Modification of Development Consent

Section 96(1A) of the *Environmental Planning and Assessment Act 1979*

Application No:	SSD 7075
Applicant:	Cleanaway Pty Ltd
Consent Authority:	Minister for Planning
Development:	Erskine Park Waste and Resource Management Facility Staged Development Application, comprising: <ul style="list-style-type: none">• A concept proposal for a Waste and Resource Management Facility (WRMF) with a maximum processing capacity of 300,000 tpa. All waste received at the WRMF shall enter the Waste Transfer Station (Stage 1), up to 150,000 tpa of this waste may be recycled at the Resource Recovery Facility (Stage 2).• Construction and operation of the Stage 1 Waste Transfer Station with a maximum processing capacity of 300,000 tpa.
Date of Original Consent:	4 October 2016
Modification:	SSD 7075 MOD 2 – Modifications to the site levels, access ramp and car parking.

MOD 2 SSD 7075 MOD 2 and supporting documentation titled *Erskine Park Waste and Resource Management Facility Modification to approved SSD 7075 Environmental Assessment Report*, prepared by EME Advisory and dated January 2018.

APPENDIX 1A – STAGE 1 AND 2 CONCEPT PROPOSAL

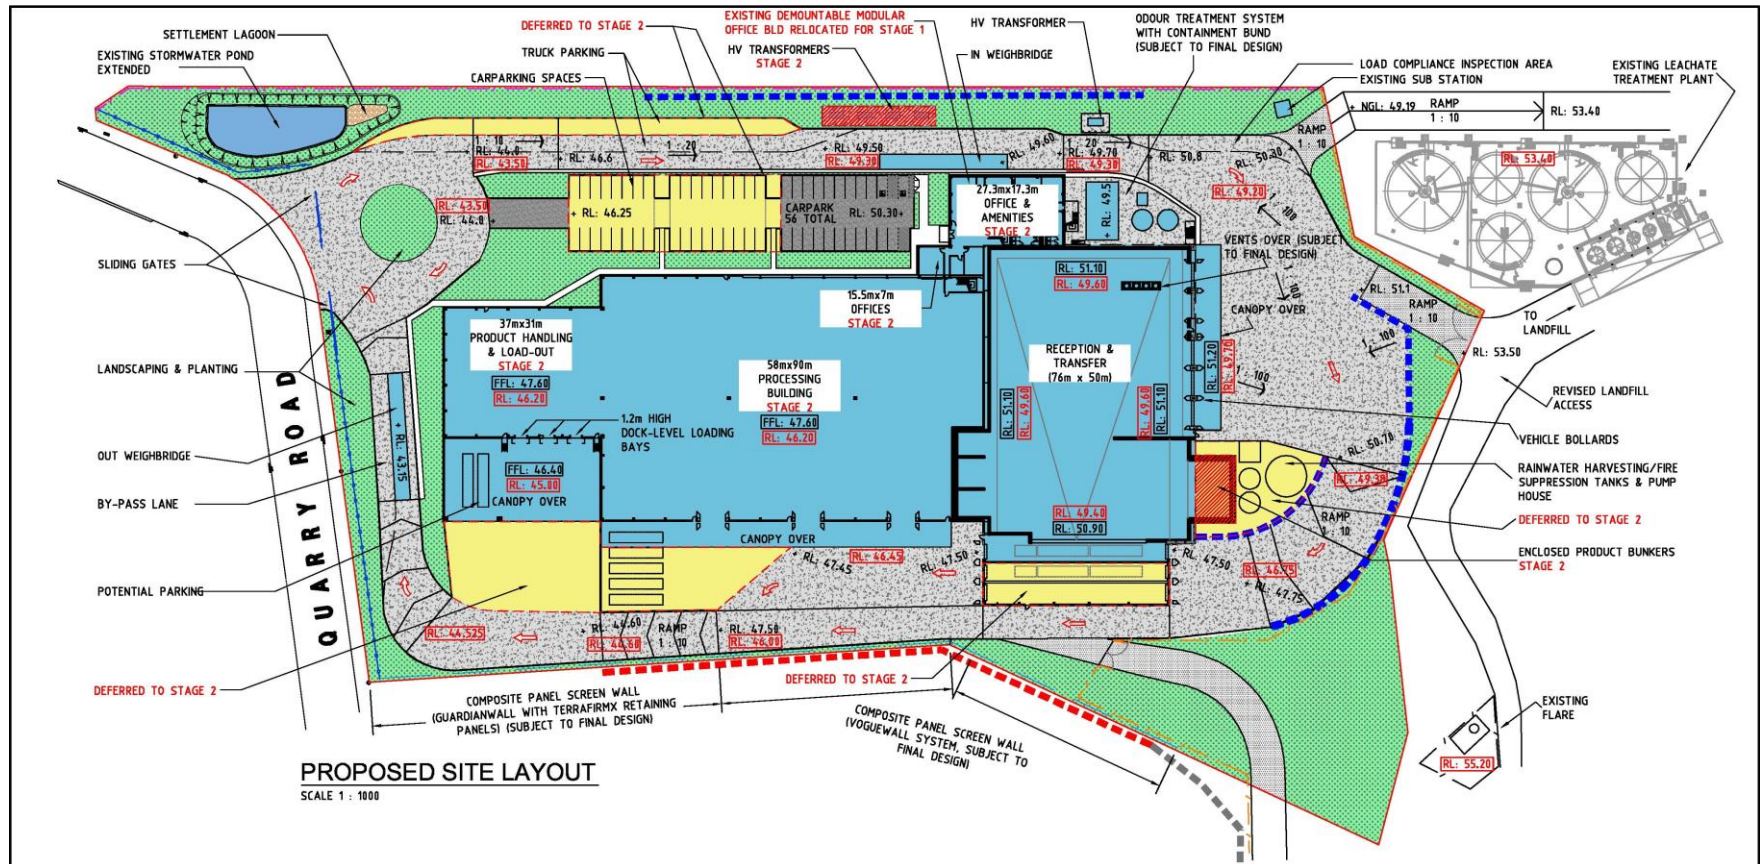
5. Replace Appendix 1A and Appendix 1B with new Appendix 1A and Appendix 1B.

APPENDIX 1B – STAGE 1 SITE LAYOUT PLAN

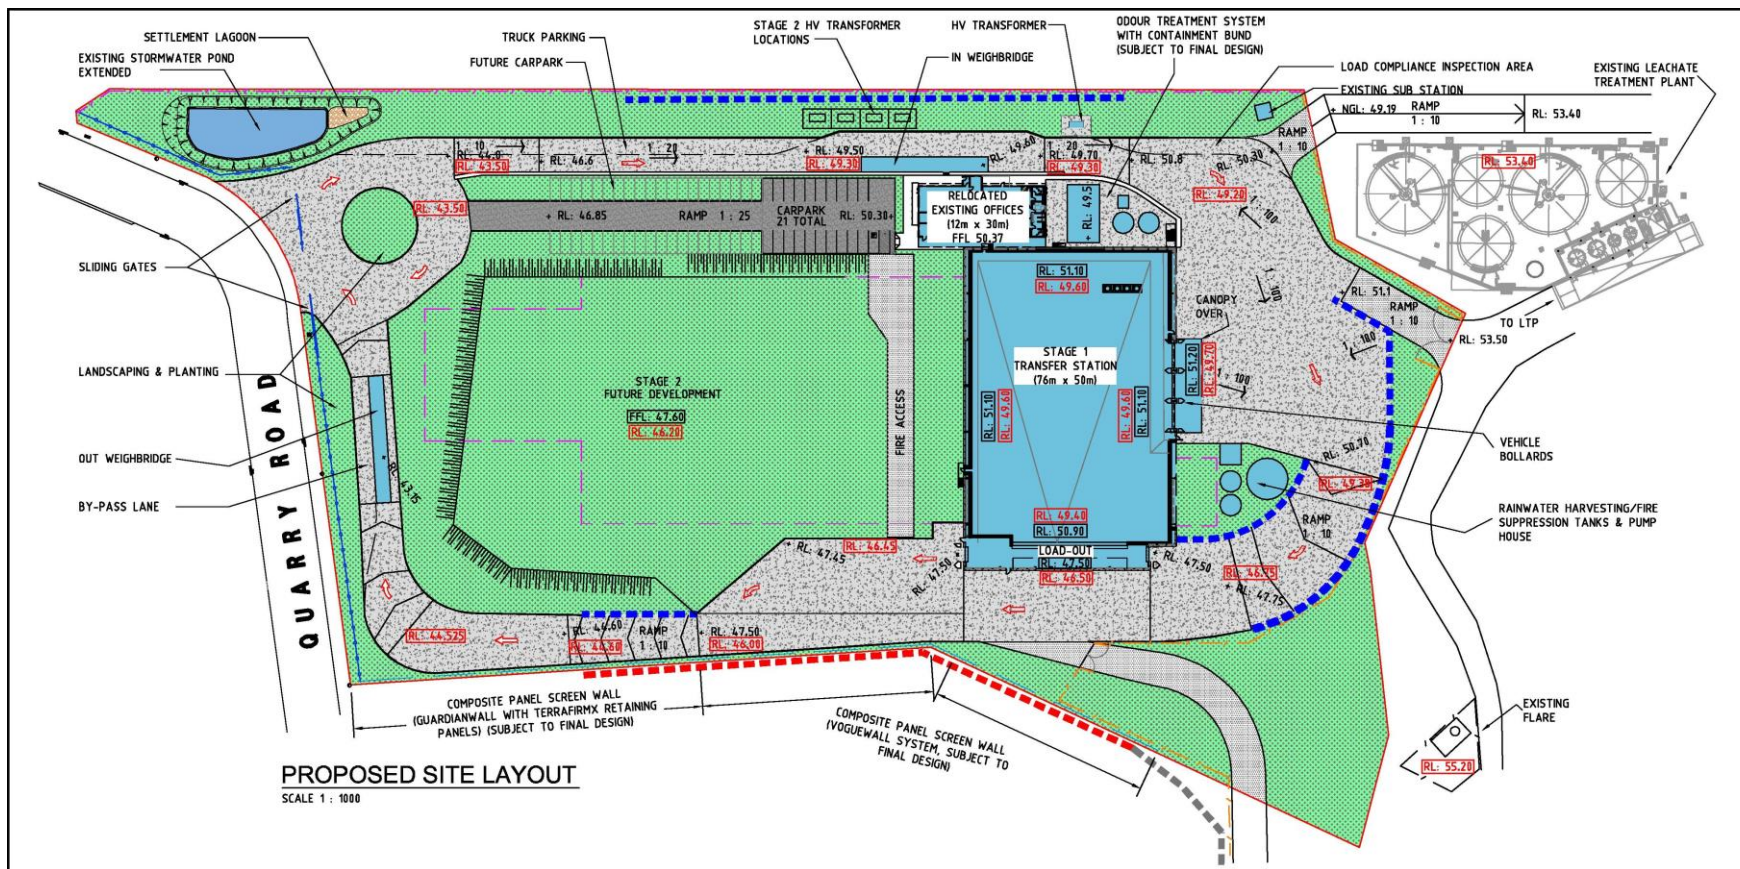
- a) a total of 21 car parking spaces, including one accessible car parking space are provided;
- b) trucks must only be parked in the designated truck park areas as identified in Appendix 1B;

APPENDIX 2 – STAGE 1 ELEVATION PLANS – WASTE TRANSFER STATION

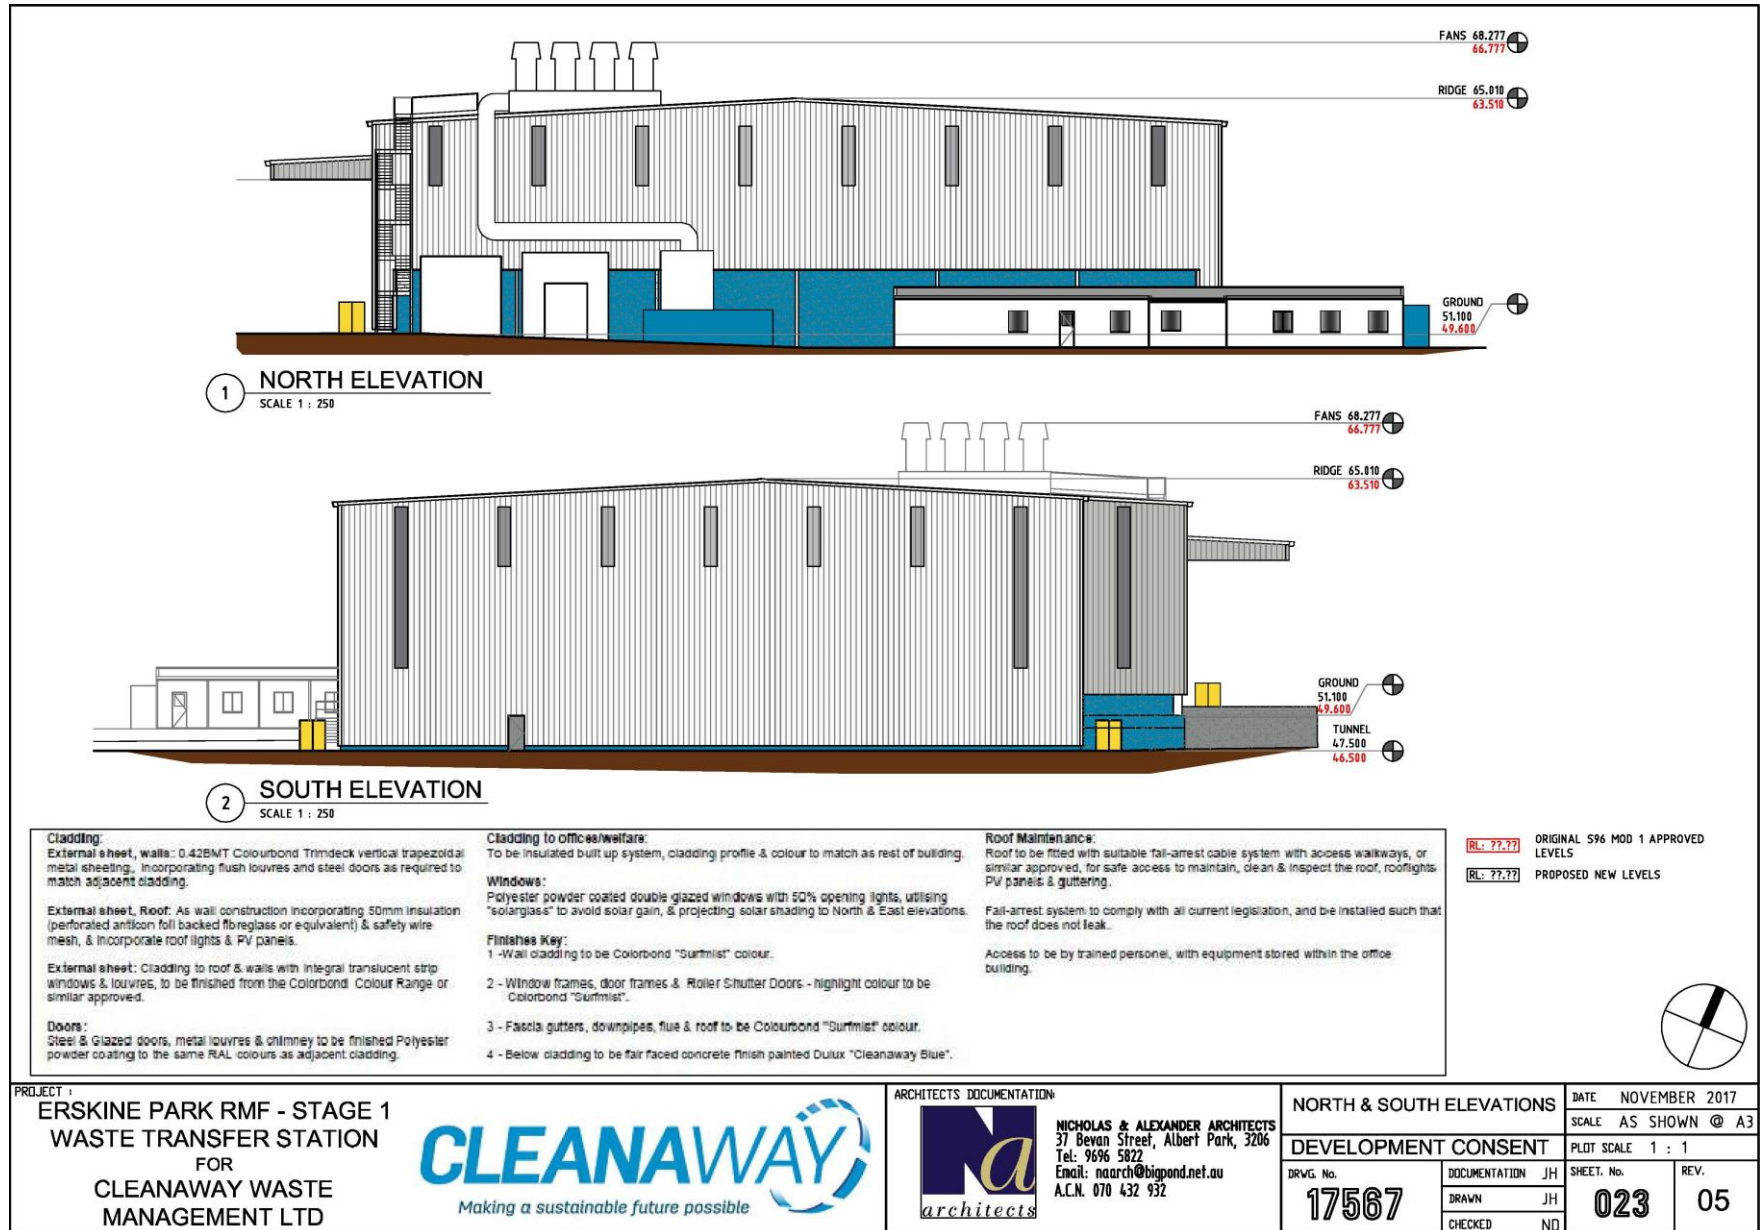
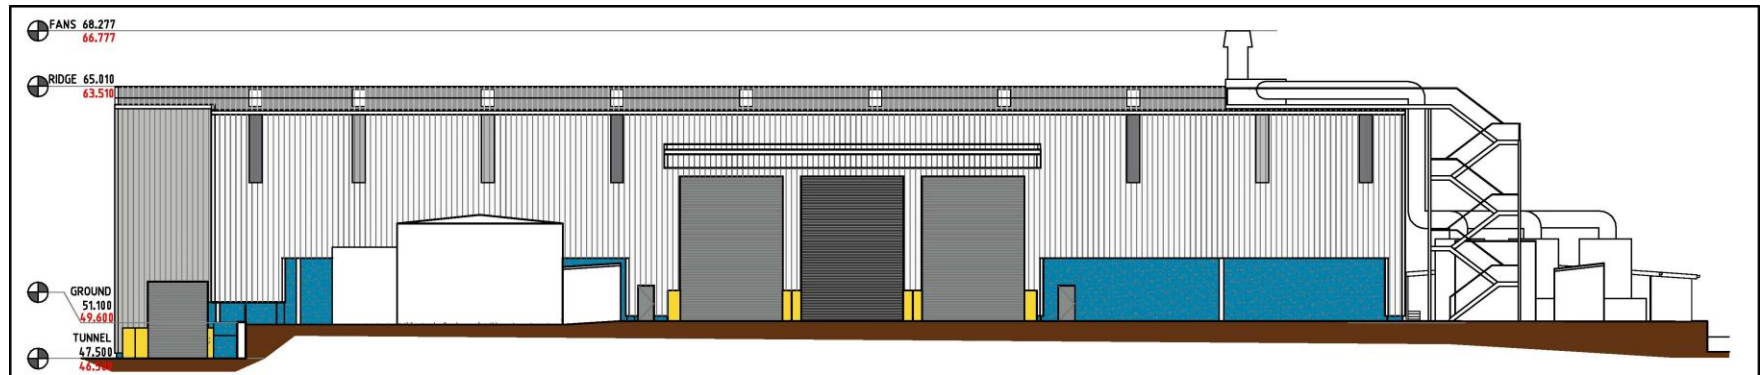
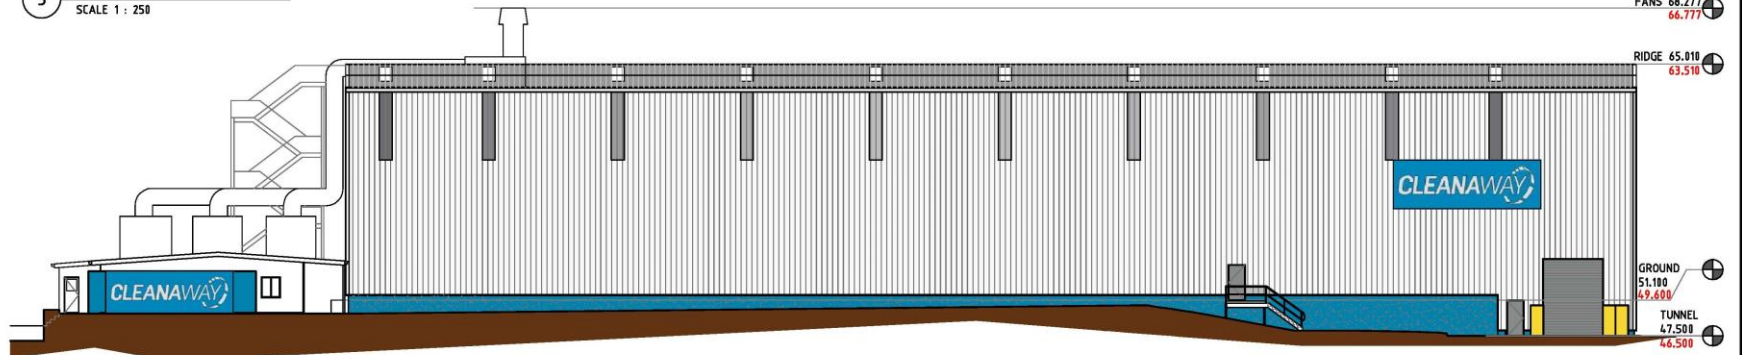
6. Replace Appendix 2 with new Appendix 2.
